RE: **Supplemental Information Request for Application No. 1523635 (the Application)
Kai Kos Dehseh Project – Athabasca Oil Sands Area**

**APPLICATION FOR APPROVAL OF
KAI KOS DEHSEH PROJECT
SUPPLEMENTAL INFORMATION REQUEST ROUND 1**

StatoilHydro				MATERIAL BALANCE			
				BITUMEN PRODUCTION 34980 m ³ /d (220,000 bpd)			
				SOR = 3, RR = 10%			
SCALE	SIZE	DRAWING NUMBER		REV			
NONE	B	FIGURE 7 - 1		C

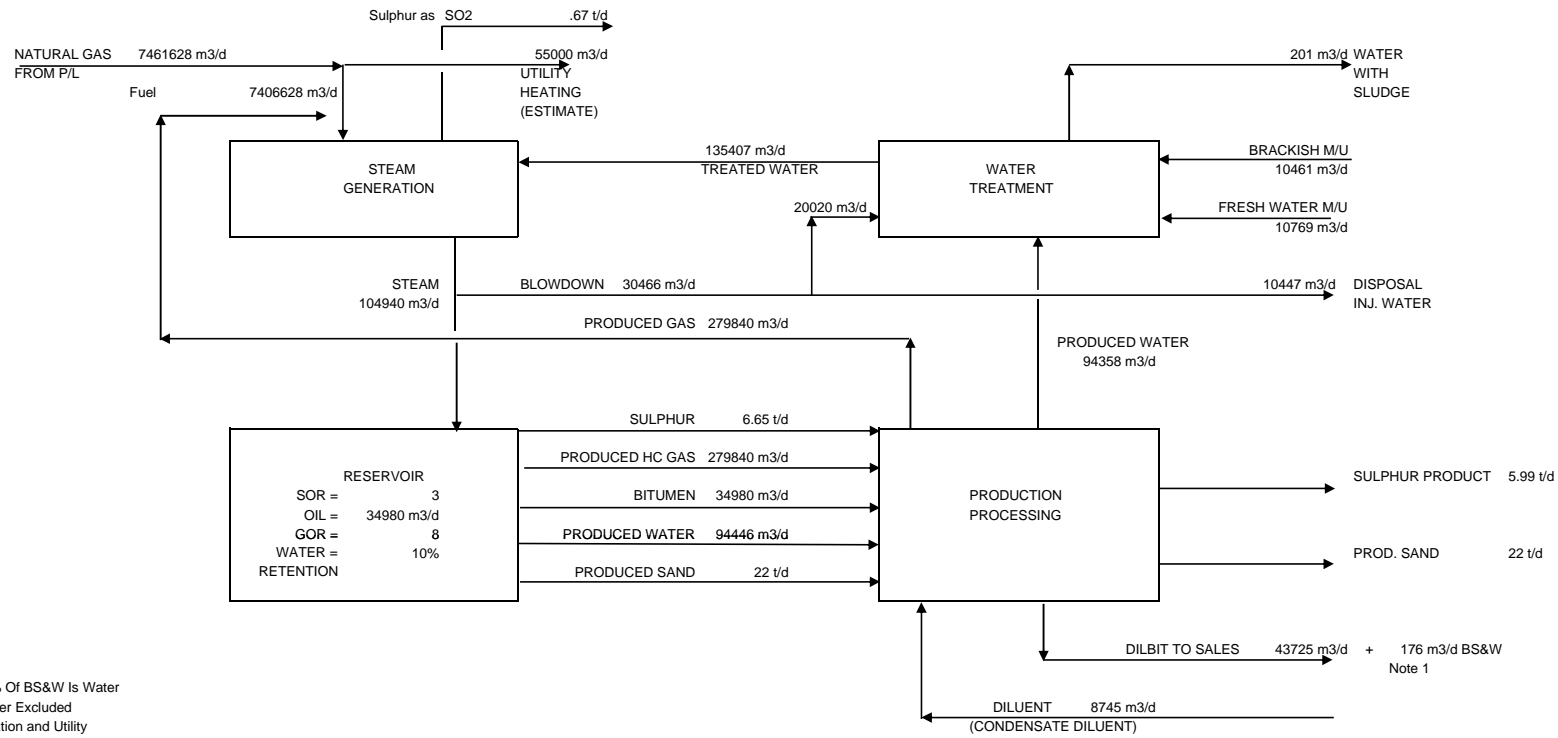
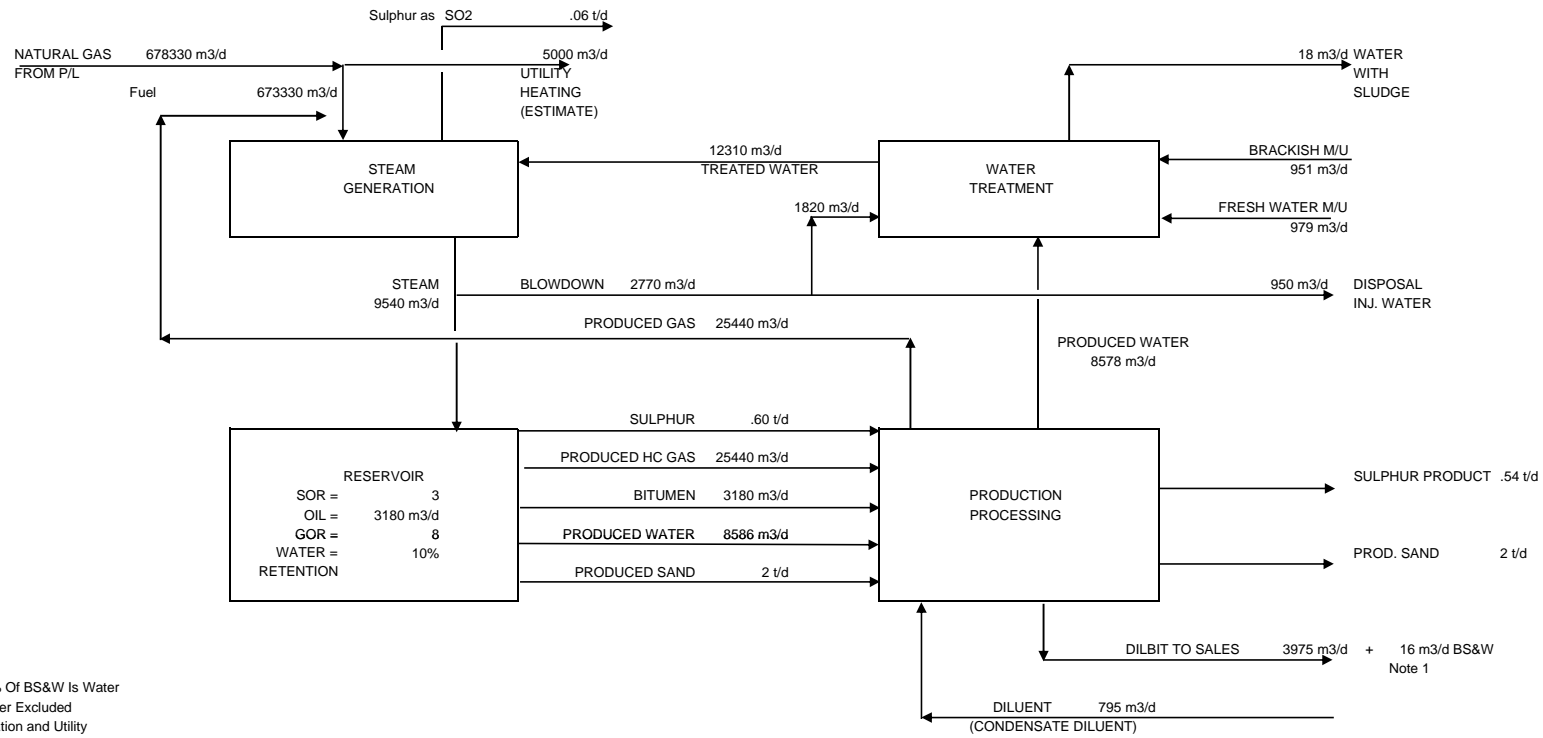
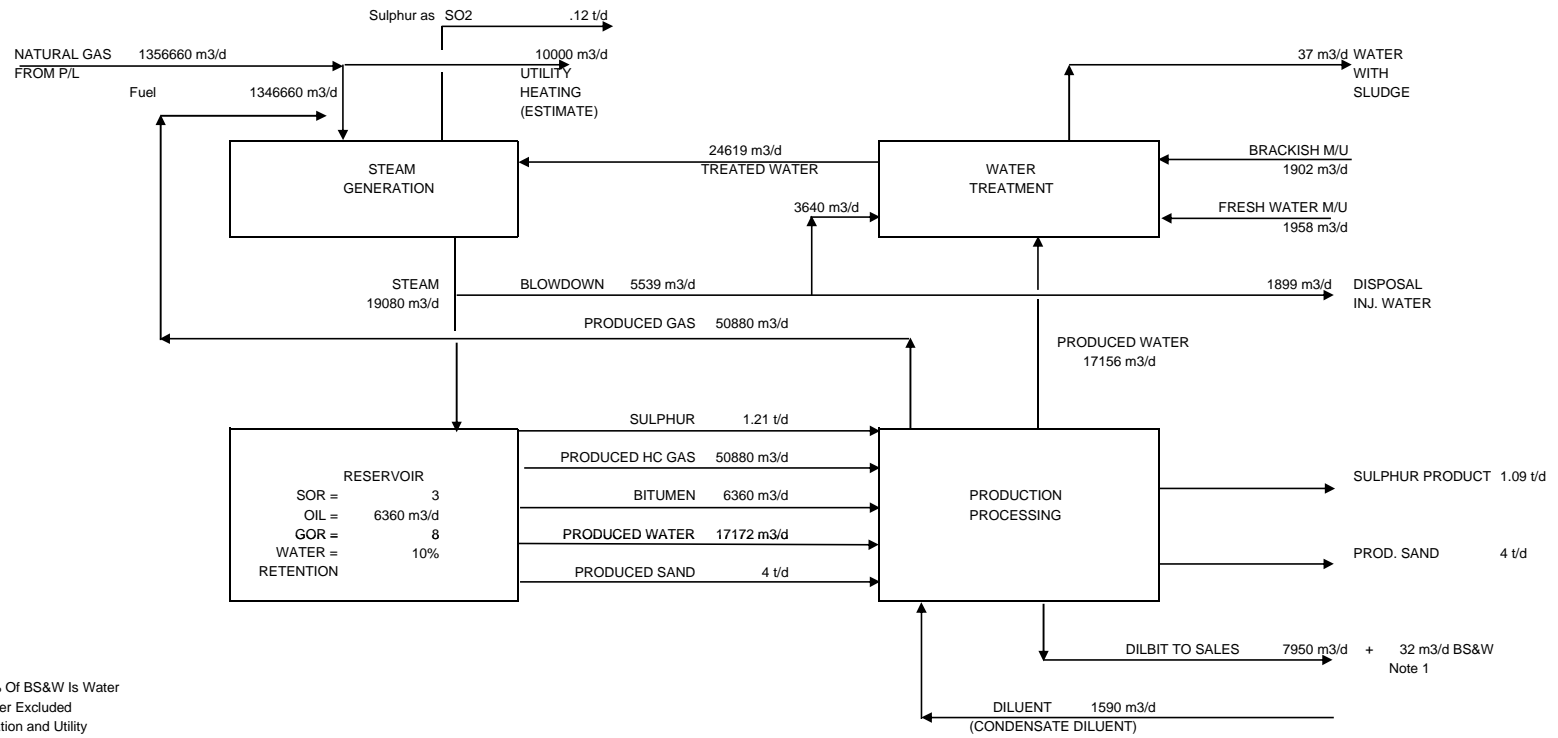
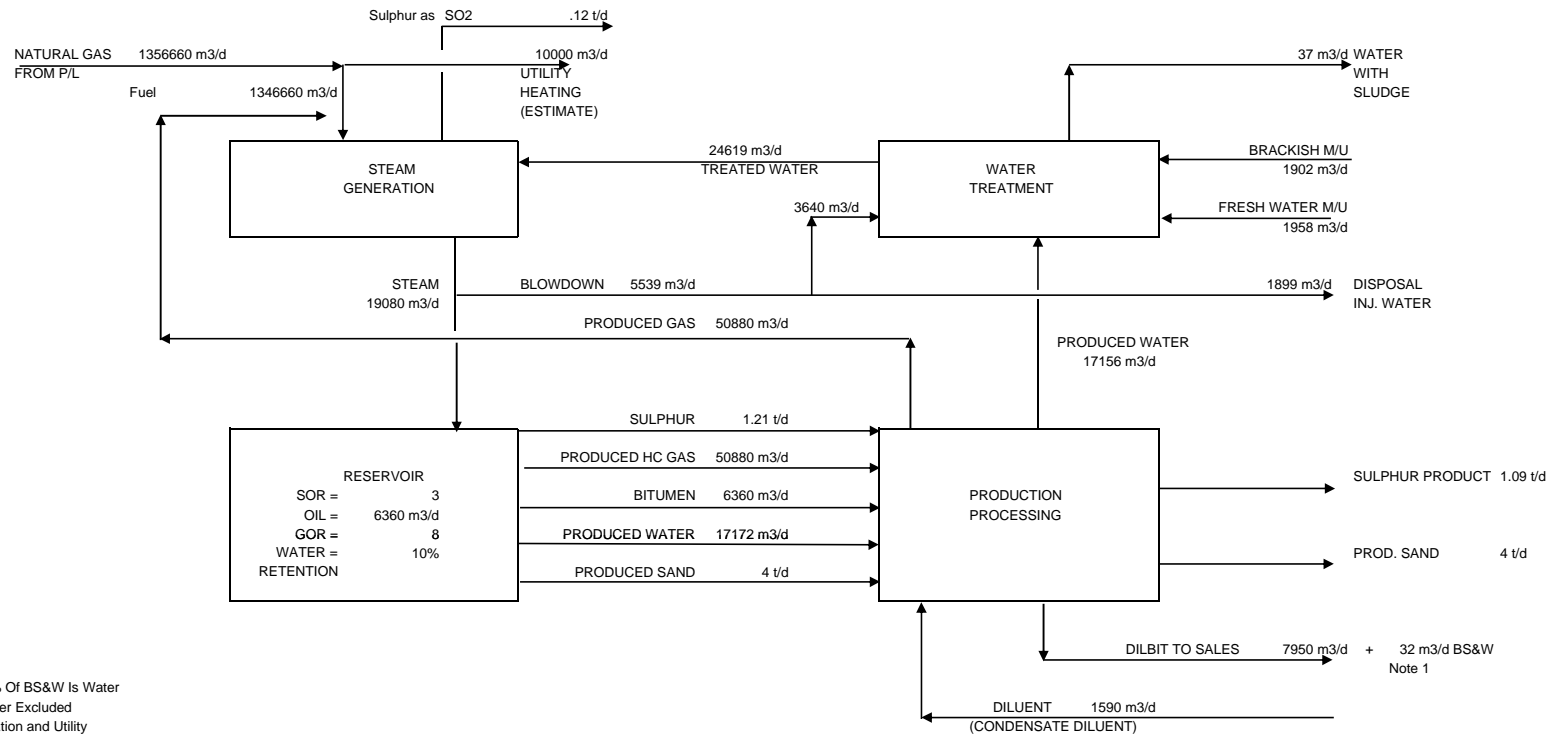
7	<p>Volume 1, Section 5.2.8, Page 100, Volume 1, Figure 5.2-8, Page 114 Volume 1, Appendix B., Figure B. 2.1-2 Volume 1, Appendix C., Figure C. 2.1-2 Volume 2, Section 2, Table 2.6-1</p> <p>a) Provide data (calculations, gas analysis, historical records) supporting the expectation of maximum sulphur content of 1.75% (Volume/Volume) hydrogen sulphide (H₂S) in produced gas (Section 5.2.8, p.101).</p>
---	--

7	<p>c) Volume 1, Figure 5.2-8 indicates a sulphur production of 8 t/day at a bitumen production of 34,980 m³/day, which calculates 0.23 kg sulphur (S) per m³ of bitumen. However, Figure B.2.1-2 in Volume 1, Appendix B, indicates a sulphur production of 2 t/day for bitumen production of 6,360 m³/day, which calculates 0.31 kg S per m³ of bitumen. Clarify this difference.</p>
---	--

The corrected numbers are as follows in Figures 7-1 – 7-4 (Figures 5.2-8, A2.2-2, B2.1-2 and C2.1-2 Revised) (based on a hydrocarbon GOR of 8 m³/m³ and a related H₂S concentration of 1.75% volume. (Note: If CO₂ is included, the GOR is 12 m³/m³.)

In Figure 7-1 (Figure 5.2-8 Revised) – for a bitumen production of 34,980 m³/d the sulphur production is 5.99 t/d relating to 0.19 kg S per m³ bitumen.

In Figure 7-3 (Figure B.2.1-2 Revised) - For a bitumen production of 6,360 m³/d the sulphur production is 1.2 t/d relating to 0.19 kg S per m³ bitumen

StatoilHydro	ENERGY EFFICIENCY BALANCE		
	BITUMEN PRODUCTION 34980 m3/d (220,000 bpd)		
	SOR = 3, RR = 10%		
SCALE	SIZE	DRAWING NUMBER	REV
NONE	B	FIGURE 12-1	B

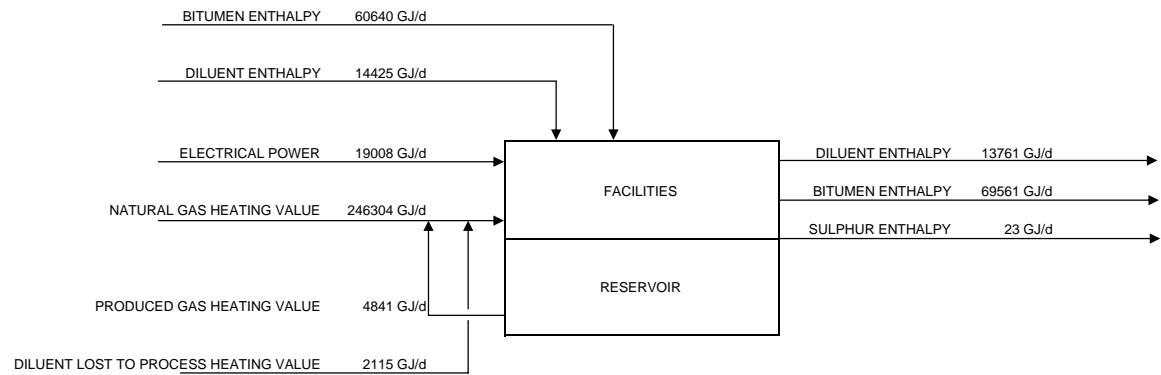
12	<p>Volume 1, Section 5.2.1, Figures 5.2-8 & 5.2-10, Pages 114 & 116</p> <p>From the material and energy balance provided in Figures 5.2-8 and 5.2-10, the resulting heating value of natural gas is about 29 MJ/m³.</p> <p>a) Provide an estimated gas composition of the fuel used in the OTSGs and its associated heating value.</p>
----	--

The material and energy balances Figure 7-1 and Figure 12-1(Figure 5.2-10 Revised) have now been corrected and there are no more disparities.

Approved:	RP	Revision Date:	07/05/22
File:	4455-Empress-07.cdr		
Drawn by:	GDE	Checked:	BW
Fig. No.:	47-1

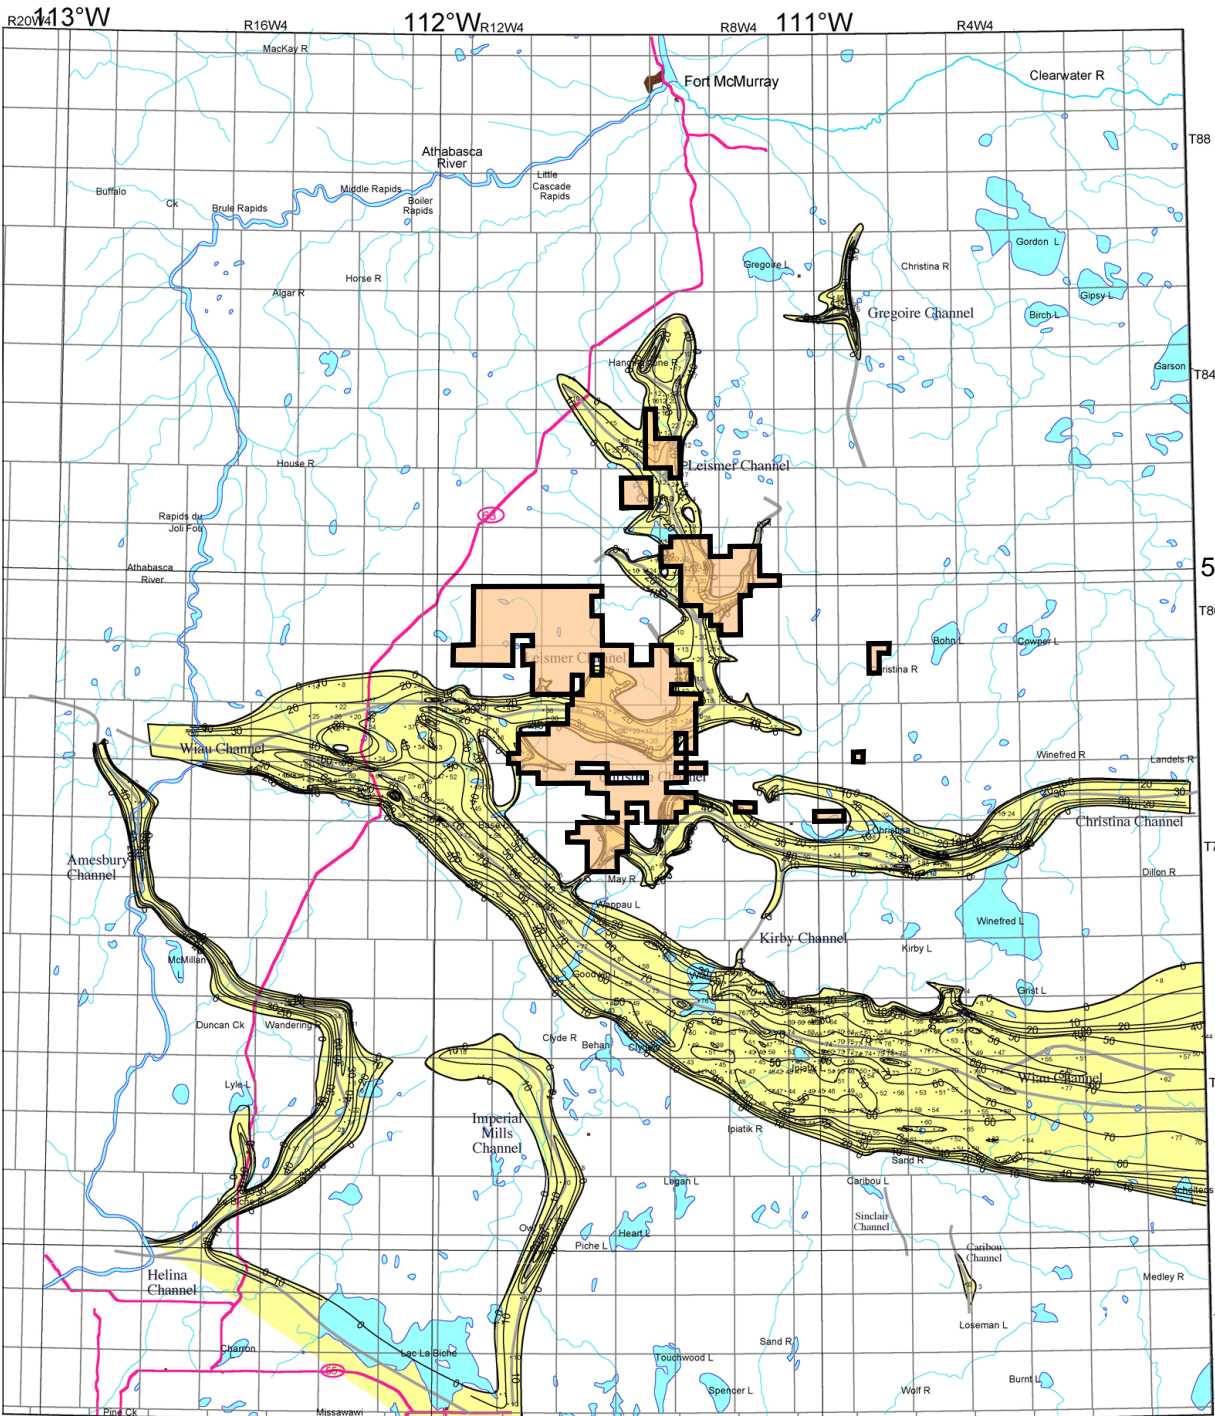
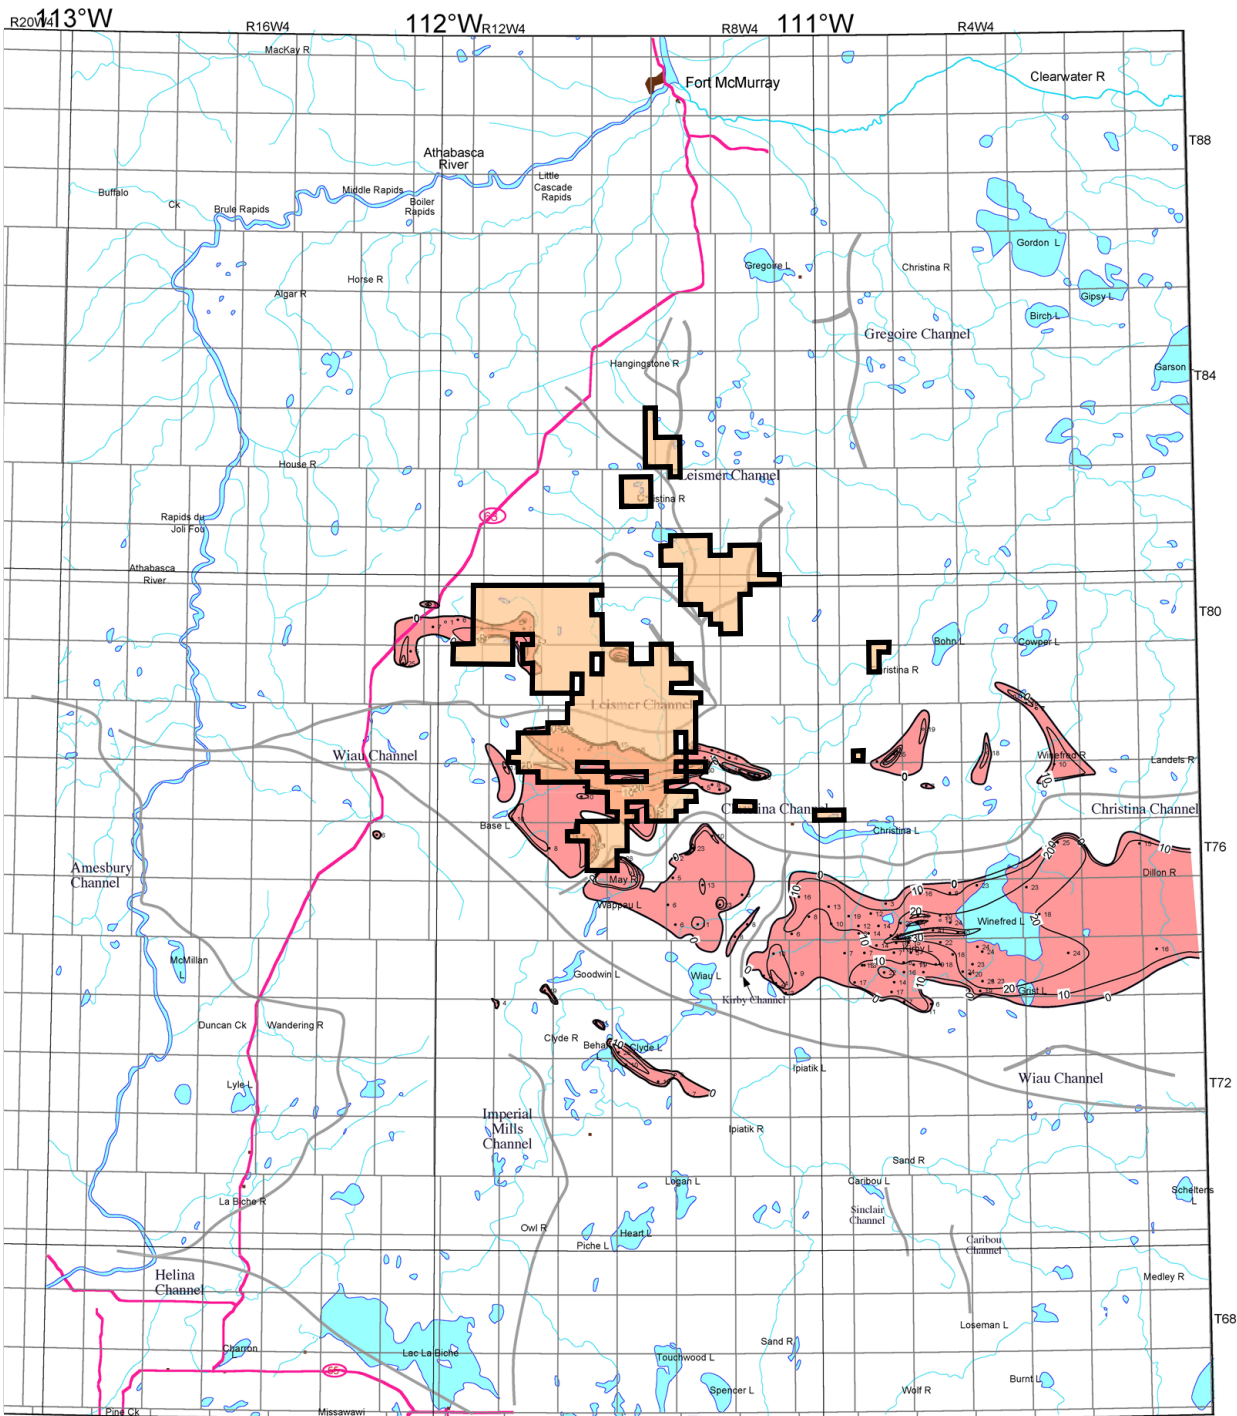
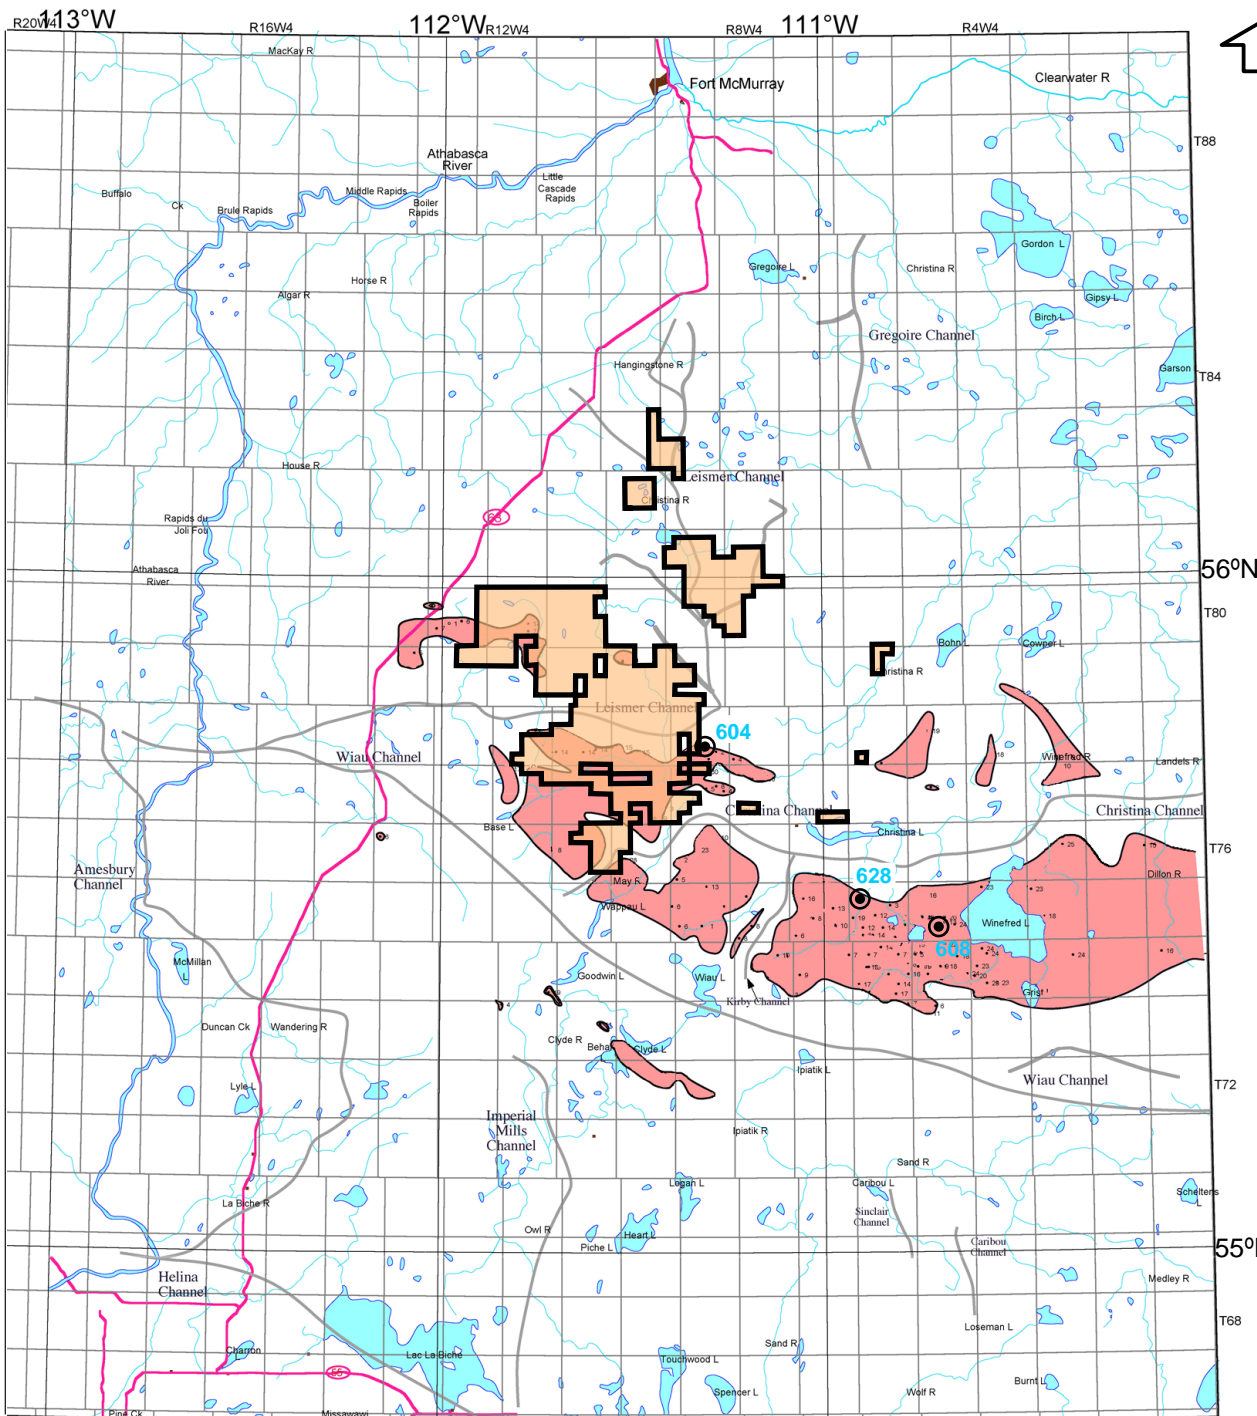
47	<p>Volume 3, Section 5, Figure 5.5.16, 5.5.17 and 5.5.22, Page 5-94 to 95</p> <p>The Figures do not outline the Project Area.</p> <p>a) Show the Project Areas so that the Empress Channel and Empress Terrace location are visible with respect to the subject area.</p>
----	--

Sufficient hydrogeologic data existed for StatoilHydro to characterize the interaction between the Empress and Grand Rapids formations for the purposes of this Application. Extensive detailed and regional mapping was conducted to understand interaction between these units. StatoilHydro also understands the important role the Joli Fou Aquitard plays in minimizing pressure decreases in the Lower Grand Rapids Aquifer, due to pumping, from fluids propagating
